RE: Florida Power & Light Company
Turkey Point Unit 4
Docket No. 50-251

Subject: Response to NRC Request for Additional Information Regarding the Responses to GL 2004-02, "Potential Impact of Debris Blockage on Emergency Recirculation During Design Basis Accidents at Pressurized-Water Reactors," TAC NO. MC4726

ATTACHMENT 1
Responses to NRC's Request for Additional Information on
FPL's Turkey Point Nuclear Plant Unit 4 (PTN4)
GL 2004-02 Response Dated February 28, 2008
and Supplemental Response dated August 11, 2008

Figure 2-1 Break S2 and Shadow Area

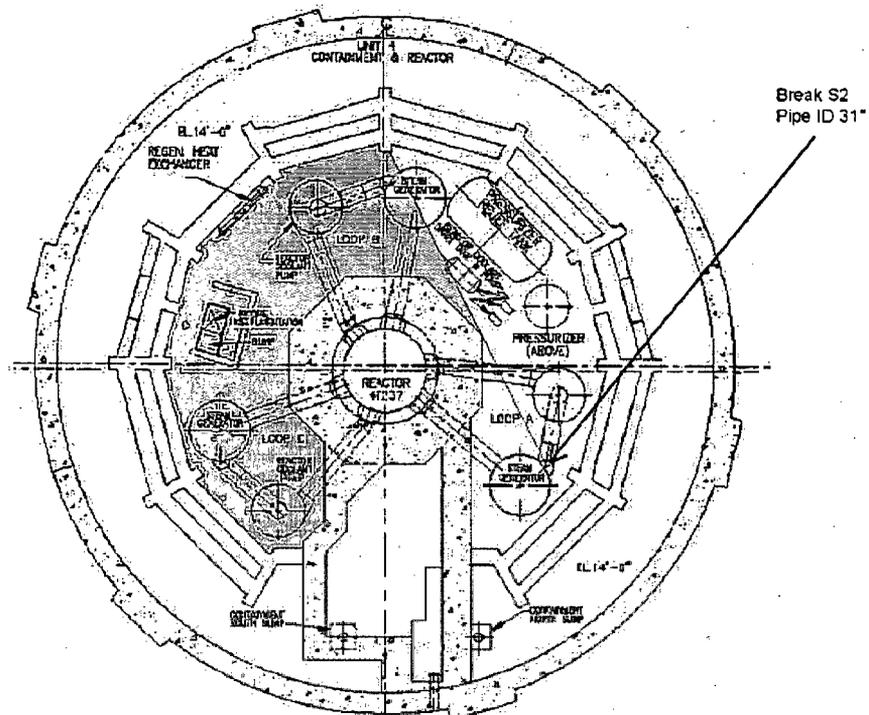
Please provide your evaluation that establishes that breaks at or near the reactor nozzle will not result in a more limiting debris generation condition than the breaks presented in the supplemental response. Please describe the insulating material(s) for the reactor vessel.

From these break location considerations, the limiting break that resulted in the bounding debris generation was S2. See Figure 2-1, below.

Figure 5-1. Plot of velocity contour at mid-depth

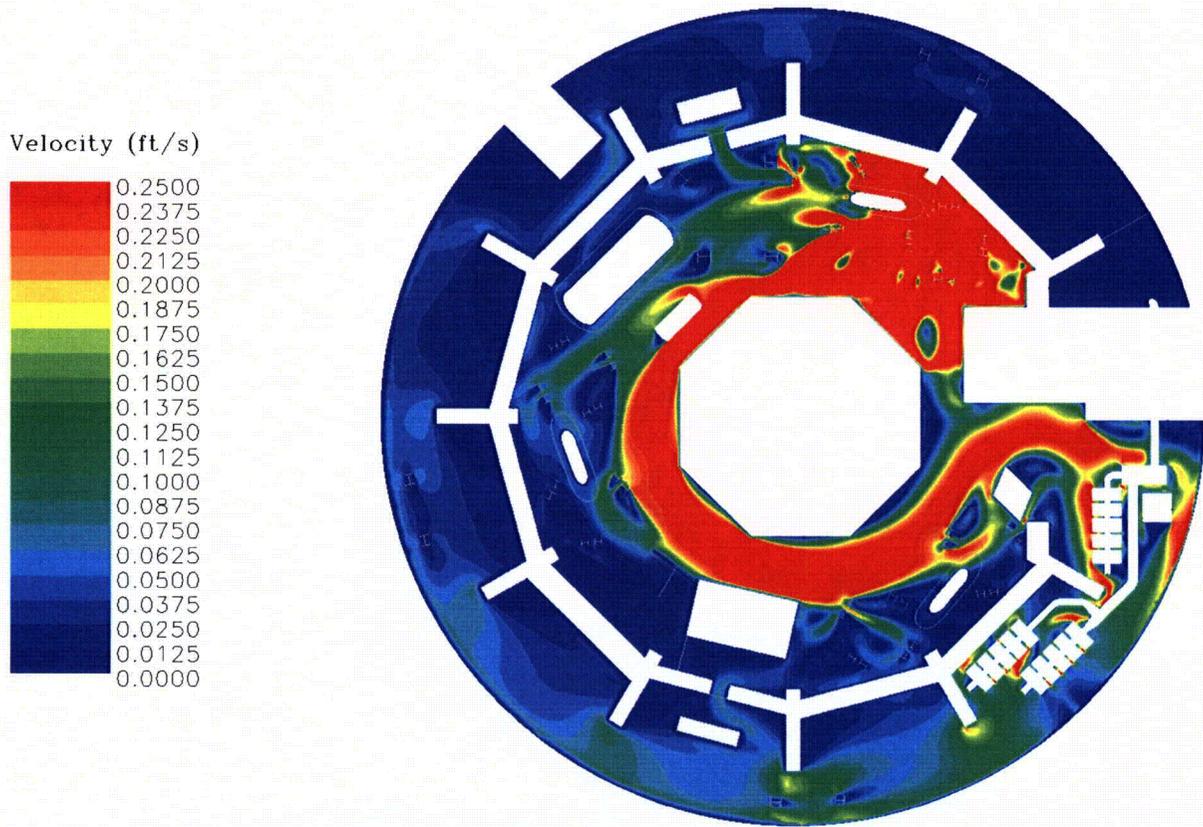
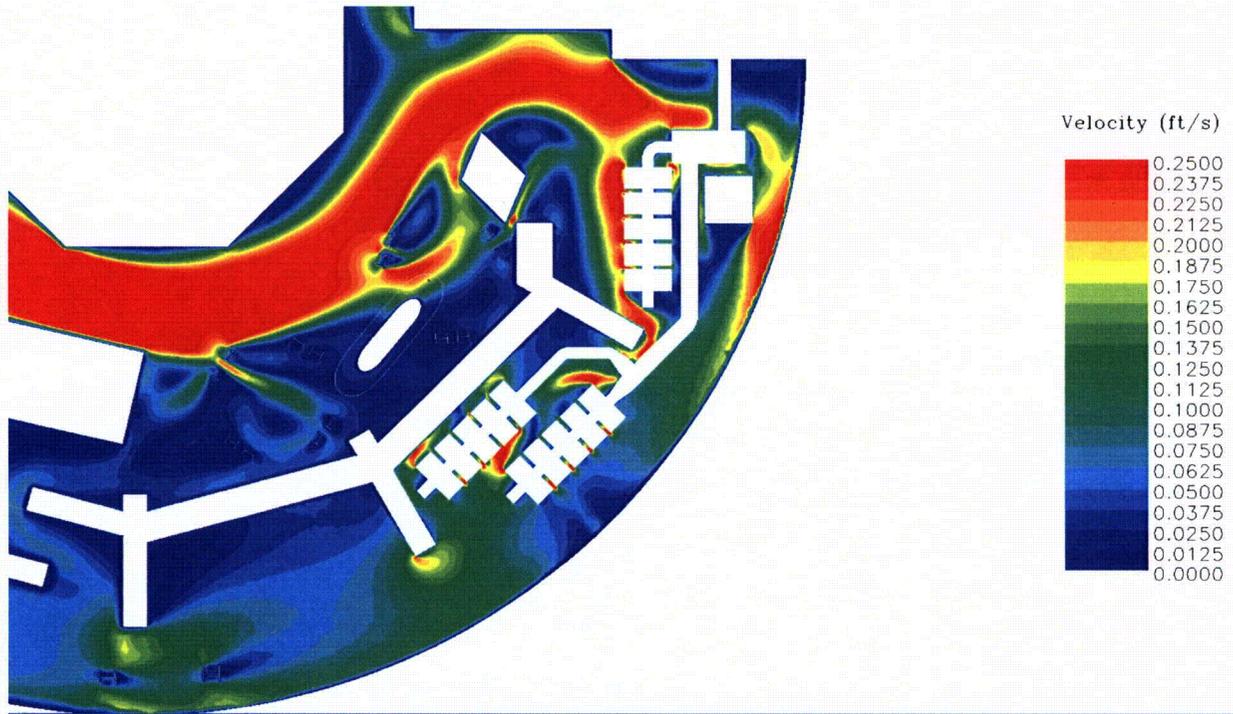
Please provide a contour plot of the containment pool velocities that includes both the velocities inside the bioshield wall and in the outer annulus. Please also provide a close-up plot of the velocity and turbulence contours in the region of the strainer and its immediate surroundings. Please also provide a table of the head loss test flume (average) velocity as a function of distance from the test strainer and identify the turbulence level simulated in the test flume.

Figure 7-1 Plot of turbulent kinetic energy within 20 feet of the strainer

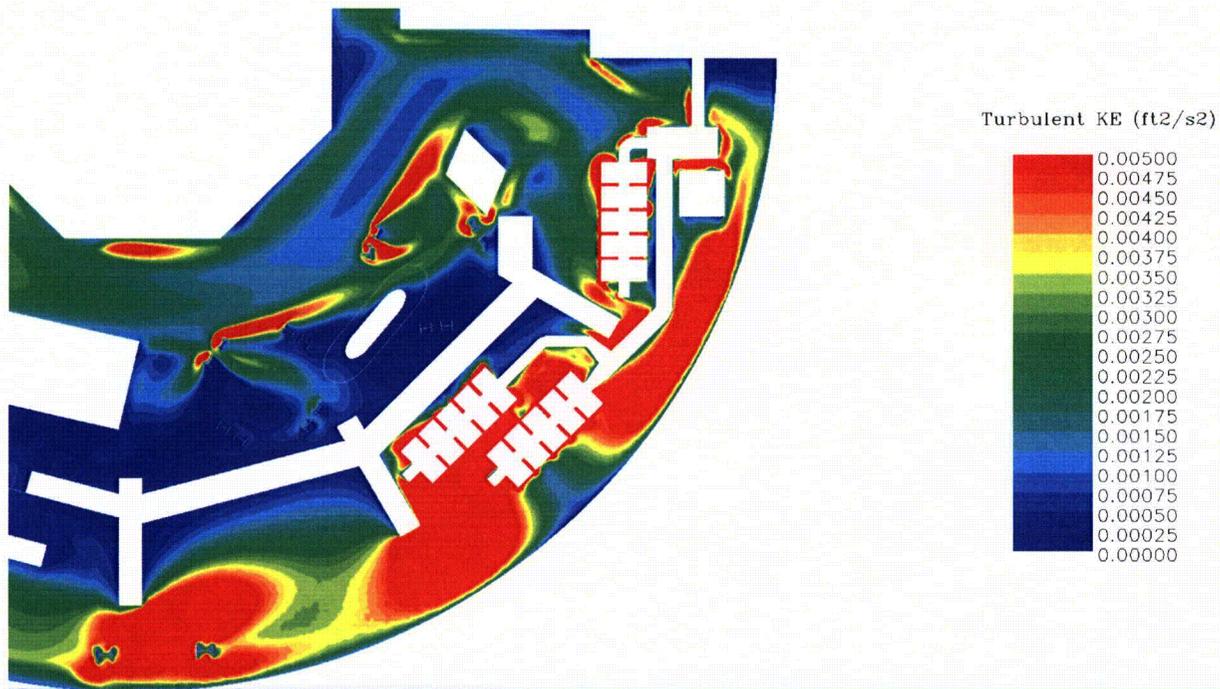
Please describe how the kinetic energy of the containment sprays entering the containment pool was modeled. Spray flow splashing into the containment pool can have a significant impact on the velocity and turbulence distributions in the containment pool. Furthermore, the drainage from the containment sprays frequently is not uniform (as is assumed for Turkey Point 4) at the containment pool elevation due to non-uniformities in the structures at higher elevations that can result in concentrated drainage (e.g., refueling canal drains, hatch openings, gaps in curbs, etc.). Please provide the justification for using a uniform spray drainage model.

Turbulent kinetic energy was specified at the water surface where the water from the sprays is assumed to enter the pool. To set a turbulence level at this inflow location, the turbulence intensity was set to 5% and the turbulent viscosity ratio was set to 5%. A kinetic energy plot is shown in Figure 7-1 below.

Figure 8-1 Isocontours of Velocity: 6 fps and above

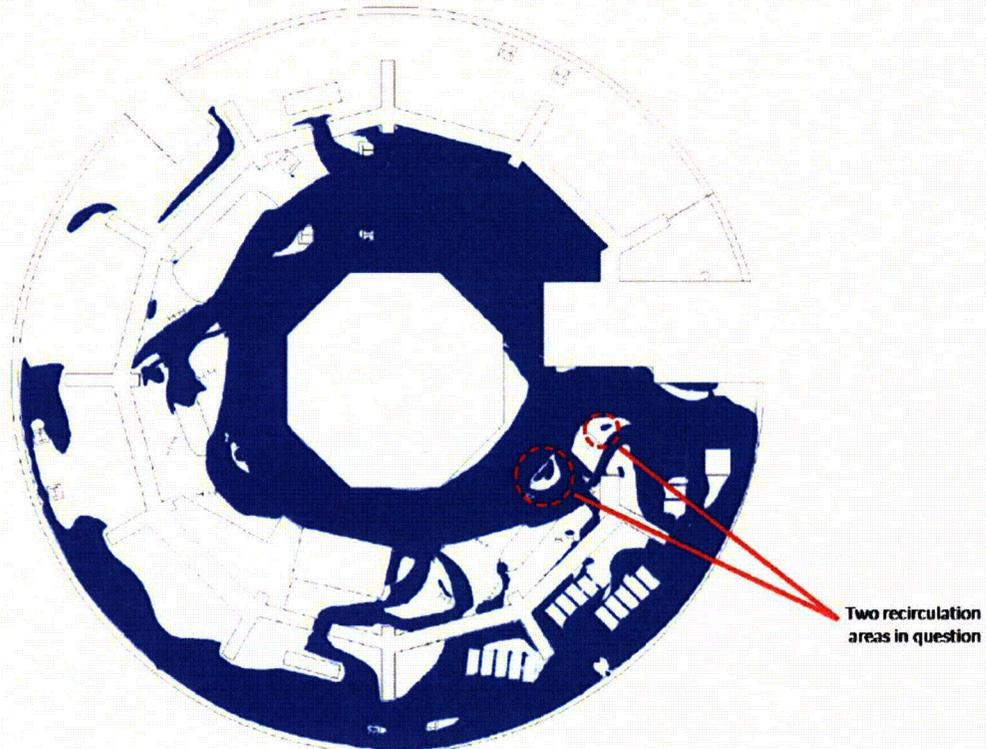
The August 11, 2008, supplemental response states on page 16 that streamline plots were used to identify isolated eddies that had velocities higher than the incipient tumbling velocity but did not contribute to debris transport from the zone. Please provide the basis for considering debris assumed to be present in this area at the switchover to recirculation to not transport to the strainers, considering the following points:

The areas of recirculation in question only exist for the 0.06 ft/s velocity contours (associated with transport of small fiberglass material) and are identified in Figure 8-1 below. The areas

within the recirculation zones represent 0.12% of the total area that transports material to the screens. The material contained in this zone is considered negligible compared to the total amount of material transported to the sump screens.

Figure 11-1 Turkey Point Unit 4 Debris Interceptor System

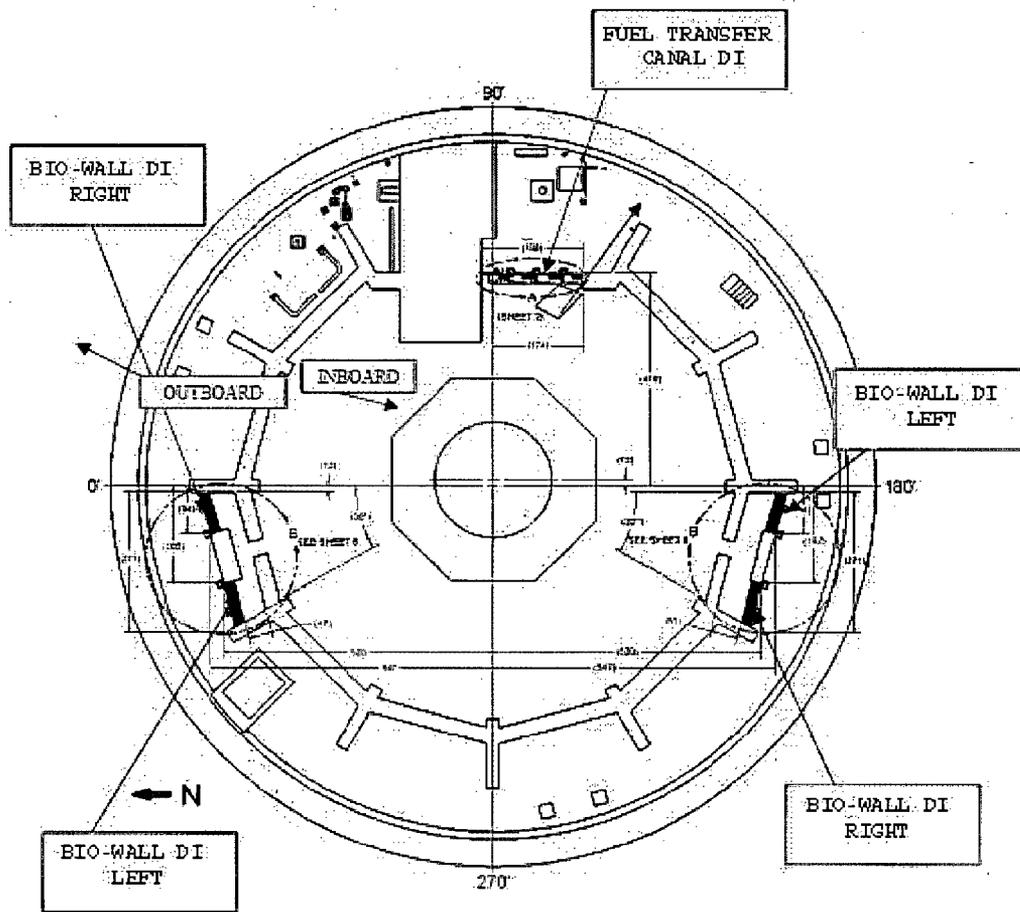
The supplemental response did not provide sufficient information concerning the debris interceptors to justify the credit apparently assumed for fibrous debris capture at the interceptors. Please provide the following information concerning the debris interceptors:

The dimensions of the roof of the test debris interceptor were 25" x 19". The roof area is 475 square inches. The installed debris interceptors are of various lengths between approximately 35 inches and 50 inches with a nominal width of approximately 19 inches. The installed debris interceptors (DIs) are designated as Bio-Wall Left, Bio-Wall-Right, and Fuel Transfer Canal. The total installed DI roof area is approximately 9000 square inches (see Figure 11-1 below).

Figure 15-2 Test Flume Configuration

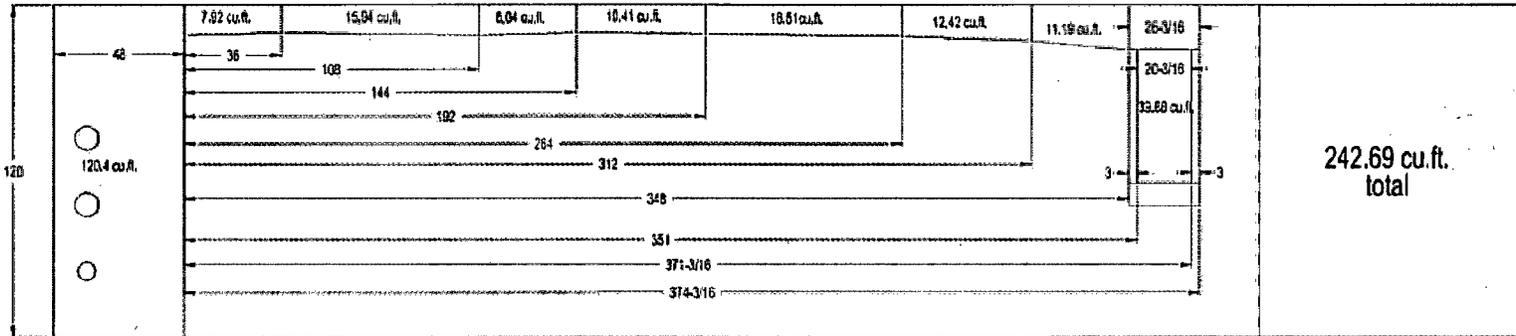
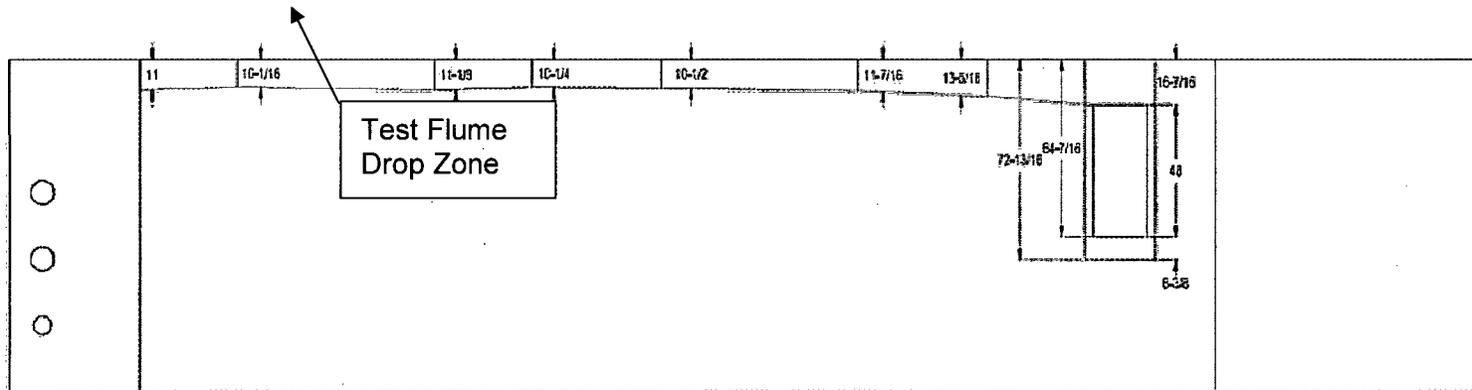
Please include: Debris introduction locations in the test flume, and the amount of each debris surrogate added to each test.

All debris types with the exception of the first batch (25% of the latent fiber) were introduced into the test flume at the drop zone. Figure 15-2, below, provides the flume wall configuration, with the drop zone for non-chemical and chemical debris labeled. From Figure 15-2, the drop zone is ~350 inches upstream of the strainer module. Batch 1 (25% latent fiber) was introduced uniformly throughout the length of the test flume. The debris amounts that were weighed and introduced into the test flume are presented in Table 15-1 below.

Figure 16-1 Plot of Measured Head Loss versus Time for Design Basis Test.

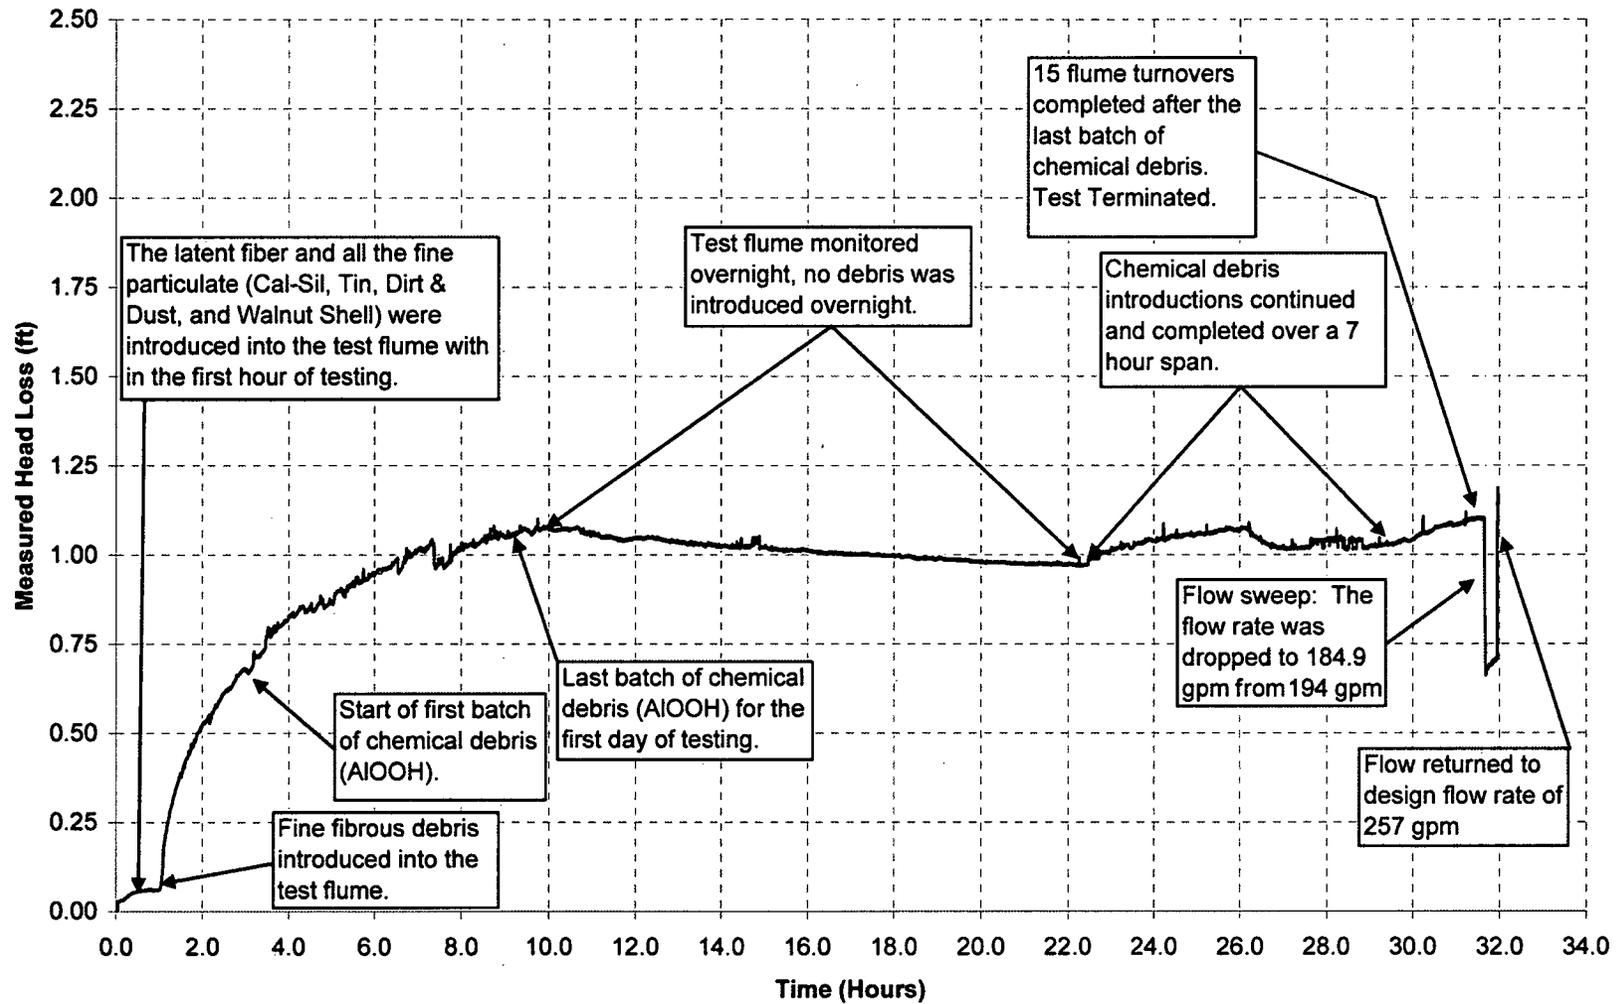
Please provide a graph of head loss versus time for the duration of the chemical effects testing, including the initial nonchemical portions. Include information regarding events that would be expected to affect the head loss such as debris addition, large flow changes, flow sweeps, etc.

Figure 16-1 below displays a plot of the measured head loss (ft) versus time (hours) for the PTN4 Design Basis Test.

Figure 18-2 Zoomed Picture of the Test Strainer during Drain Down

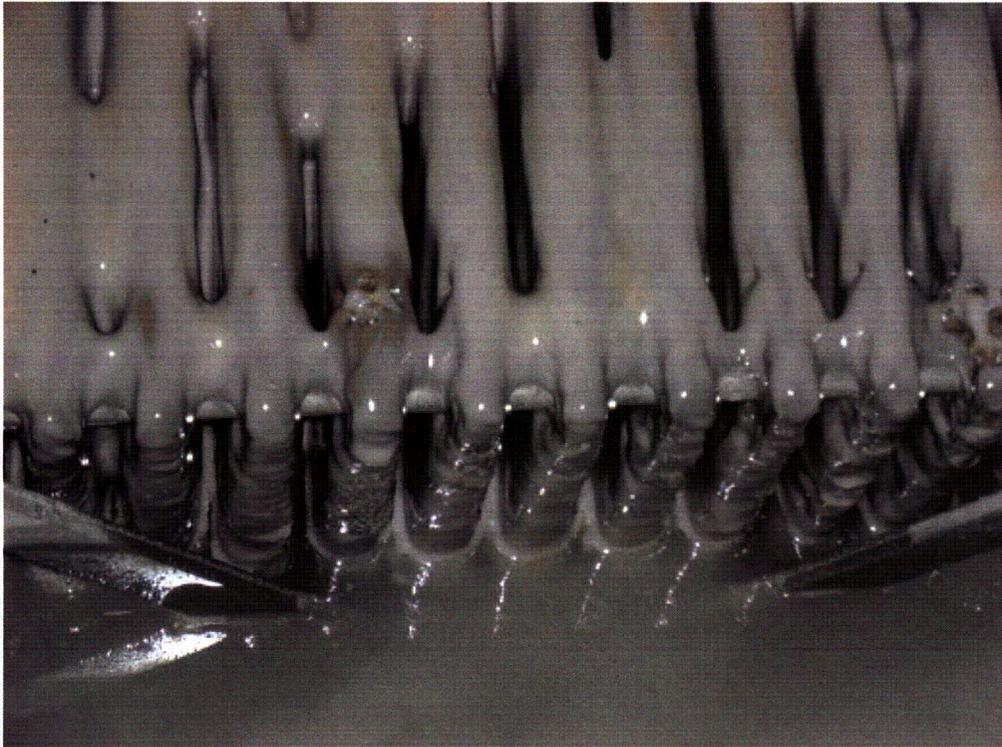
The supplemental response stated that the head loss determined by testing was extrapolated to higher temperatures expected during recirculation. The supplemental response indicated that a fiber-only test resulted in significant clean strainer area. It was not stated whether there were clean strainer areas following testing with chemicals and particulates. Clean strainer can result in turbulent flow which complicates attempts to viscosity correct head loss results to higher temperatures. It was not stated whether bore holes or other pressure driven phenomena occurred during testing. Flow sweeps should have been conducted to assure that a temperature extrapolation of head loss test data was valid. State the assumptions and their bases for the temperature extrapolation evaluation. Please state whether there was clean strainer area following the limiting chemical effects test. State whether there were bore holes or similar phenomena that occurred during testing.

After drain down, the strainer had a bed of chemical debris covering the entire surface of the strainer, and there appeared to be no evidence of open strainer surface area. Thus, there were no clean strainer areas on the test strainer module, which can be seen in the pictures taken during test flume drain down. Figure 18-1 provides a picture at the start of test flume drain down with debris settled on top of the strainer module. Figure 18-2 shows a zoomed view of the top and front edge of the strainer module during drain down.
